UNITED STATES PATENT AND TRADEMARK OFFICE

APPLICATION NO.	FILING DATE	FIRST NAMED INVENTOR	ATTORNEY DOCKET NO.	CONFIRMATION NO.
10/500,248	06/25/2004	Michel Berdoyes	BDL-461XX	8913

Office Action Summary

DETAILED ACTION

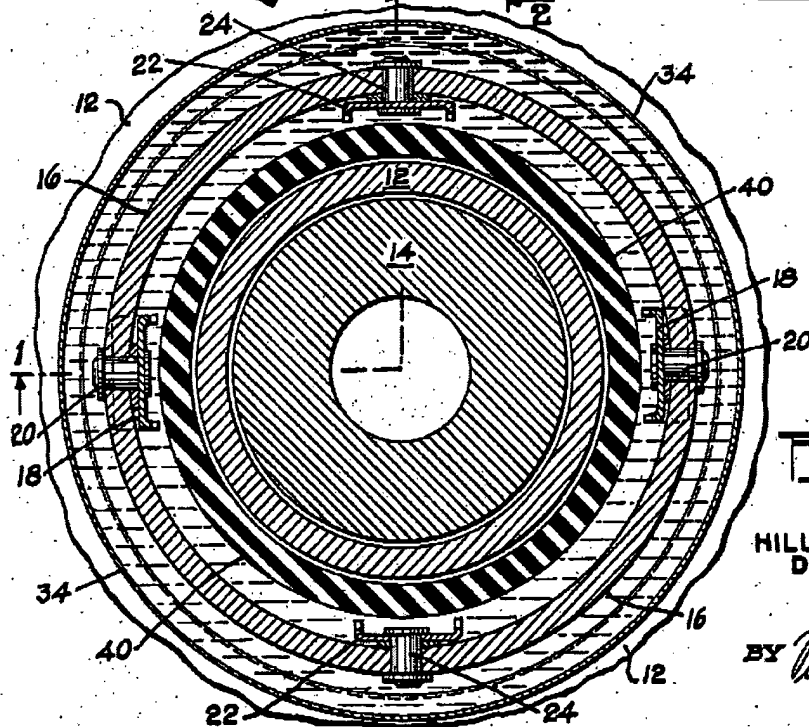
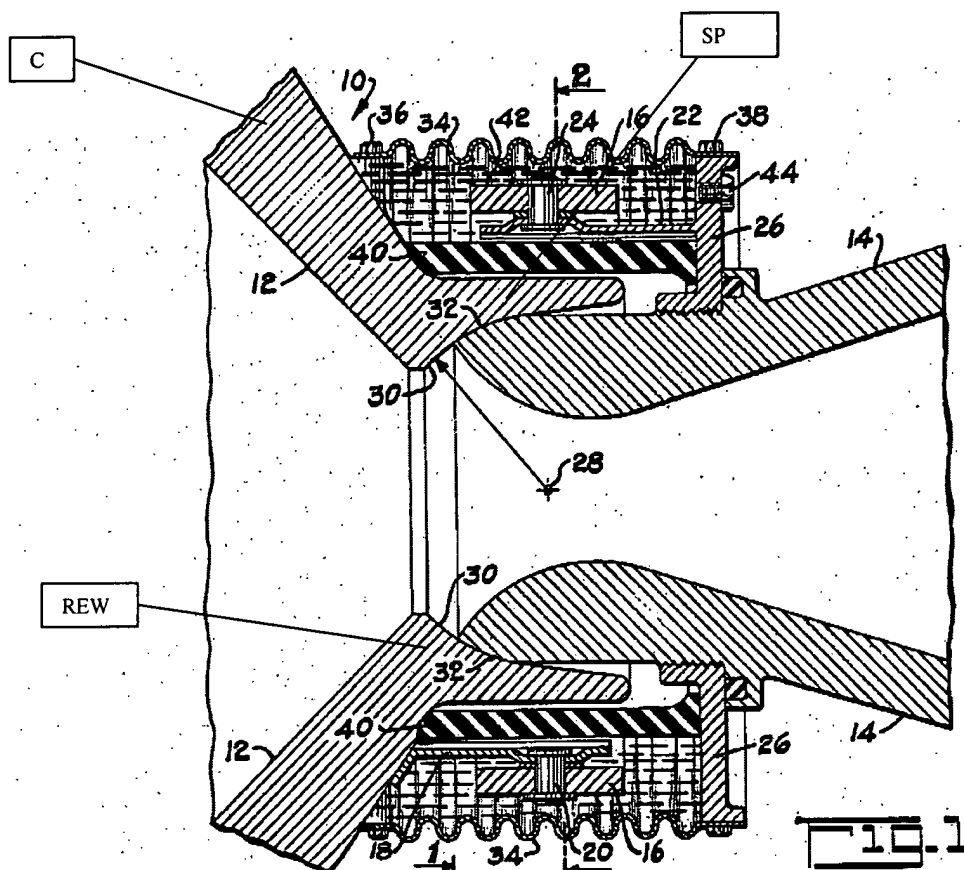
With respect to claim 1, **Barrett** teaches a steerable nozzle for rocket engine comprising: casing (C) surrounding a combustion chamber and having rear end wall (REW); a nozzle comprising moving diverging portion (14) and a static portion (SP) secured to the rear end wall; a jointed link device connecting the moving diverging portion of the nozzle to the static portion, the moving diverging portion and the static portion being in mutual contact via respective spherical surfaces (30, 32); and an actuator device (not shown but mentioned, column 1 line 68-column 2 line 2) acting on the moving diverging portion of the nozzle to enable the direction of the thrust vector of the engine to be varied by modifying the orientation of the nozzle with the spherical surfaces sliding one on the other, resilient return means (34) are interposed between the moving diverging portion (14) of the nozzle and the static portion (SP), said resilient return means acting on the moving diverging portion to urge it towards the static portion so as to keep the spherical surfaces (30, 32) in mutual contact for any desired orientation of the nozzle. See particularly **Figures 1, 2** of Barrett.

Note: the jointed link device or cardan mount can be comprised of the following elements: 22, 26, 36, 18, 20, 24, 16, 34, 40, 38, 44.

With respect to claim 2, **Barrett** teaches that the link device is a cardan mount comprising a ring (16), two first link arms (22) connecting the moving diverging portion (14) of the nozzle to the ring via two first hinges (24), and two second link arms (18) connecting the ring to the rear end wall of the casing via two second hinges (20), the resilient return means (34) are integrated in link arms. See particularly **Figures 1, 2** of Barrett.

With respect to claim 3, **Barrett** teaches that resilient return means 34 are integrated in the first link arms (22). See particularly **Figures 1, 2** of Barrett.

With respect to claim 5, **Barrett** teaches that the resilient return means (34 or 16 or 40) are constituted at least in part by an elastically deformable part of the link device which is elastically deformed on assembly. See particularly **Figures 1, 2** of Barrett.

With respect to claim 6, **Barrett** teaches that the resilient return means are constituted at least in part by the ring (16) of the cardan mount which is elastically deformable and is elastically deformed on assembly. See particularly **Figures 1, 2** of Barrett.

With respect to claim 12, **Barrett** teaches a steerable nozzle for a rocket engine comprising: a casing C surrounding a combustion chamber and having a rear end wall REW; a nozzle comprising a moving diverging portion 14 and a static portion SP secured to the rear end wall; a cardan mount connecting the moving diverging portion of the nozzle to the static portion, the moving diverging portion and the static portion being in mutual contact via respective spherical surfaces 30, 32, the cardan mount comprising a ring 16, two first link arms 22 connecting the moving diverging portion of the nozzle to the ring 16 via two first hinges 24, and two second link arms 18 connecting the ring 16 to the rear end wall of the casing via two second hinges 20; an actuator device (not shown but mentioned, column 1 line 68- column 2 line 2) acting on the moving diverging portion 14 of the nozzle to enable the direction of the thrust vector of the engine to be varied by modifying the orientation of the nozzle with the spherical surfaces sliding one on the other; and resilient return means 34 or 40 integrated in link arms of the cardan mount and acting on the moving diverging portion to urge it towards the static portion so as to keep the spherical surfaces in mutual contact for any desired orientation of the nozzle. See particularly **Figures 1, 2** of Barrett.

With respect to claim 13, **Barrett** teaches a steerable nozzle for a rocket engine comprising: a casing C surrounding a combustion chamber and having a rear end wall REW; a nozzle comprising a moving diverging portion 14 and a static portion SP secured to the rear end wall; a cardan mount connecting the moving diverging portion of the nozzle to the static portion, the moving diverging portion and the static portion being in mutual contact via respective spherical surfaces 30, 32; and an actuator device (not shown but mentioned, column 1 line 68-column 2 line 2) acting on the moving diverging portion the nozzle to enable the direction of the thrust vector of the engine to be varied by modifying the orientation of the nozzle with the spherical surfaces sliding one on the other; the ring 16 or 40 of the cardan mount being elastically deformed on assembly to act on the moving diverging portion to urge it towards the static portion so as to keep the spherical surfaces in mutual contact for any desired orientation of the nozzle. See particularly **Figures 1, 2** of Barrett.

FIG. 2

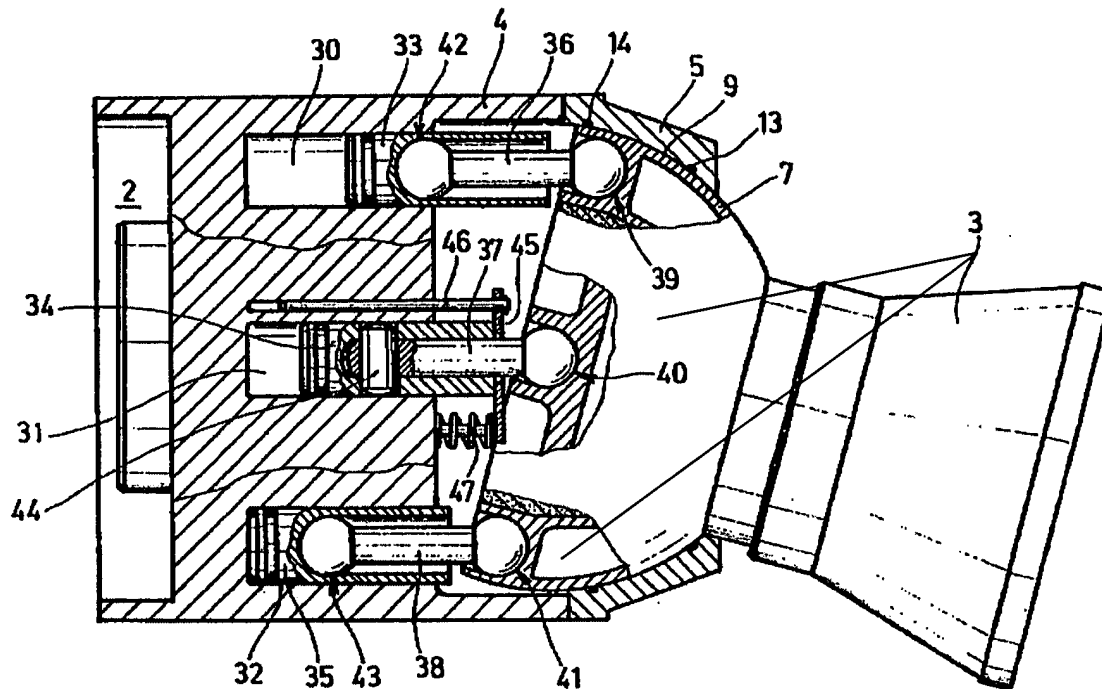
With respect to claim 1, **Rossmanith** teaches a steerable nozzle for rocket engine comprising: casing (4) surrounding a combustion chamber and having rear end wall; a nozzle comprising moving diverging portion (3) and a static portion (5) secured to the rear end wall; a jointed link device (6, see Figure 1) connecting the moving diverging portion of the nozzle to the static portion, the moving diverging portion and the static portion being in mutual contact via respective spherical surfaces (7, 9); and an actuator device (36-38) acting on the moving diverging portion of the nozzle to enable the direction of the thrust vector of the engine to be varied by modifying the orientation of the nozzle with the spherical surfaces sliding one on the other, resilient return means (47) are interposed between the moving diverging portion (3) of the

nozzle and the static portion (5), said resilient return means acting on the moving diverging portion to urge it towards the static portion so as to keep the spherical surfaces (30, 32) in mutual contact for any desired orientation of the nozzle. See particularly **Figures 1, 2** of Rossmanith.

With respect to claim 4, **Rossmannith** teaches that the resilient return means 47 comprise pre-stressed springs. See particularly **Figure 2** of Rossmanith
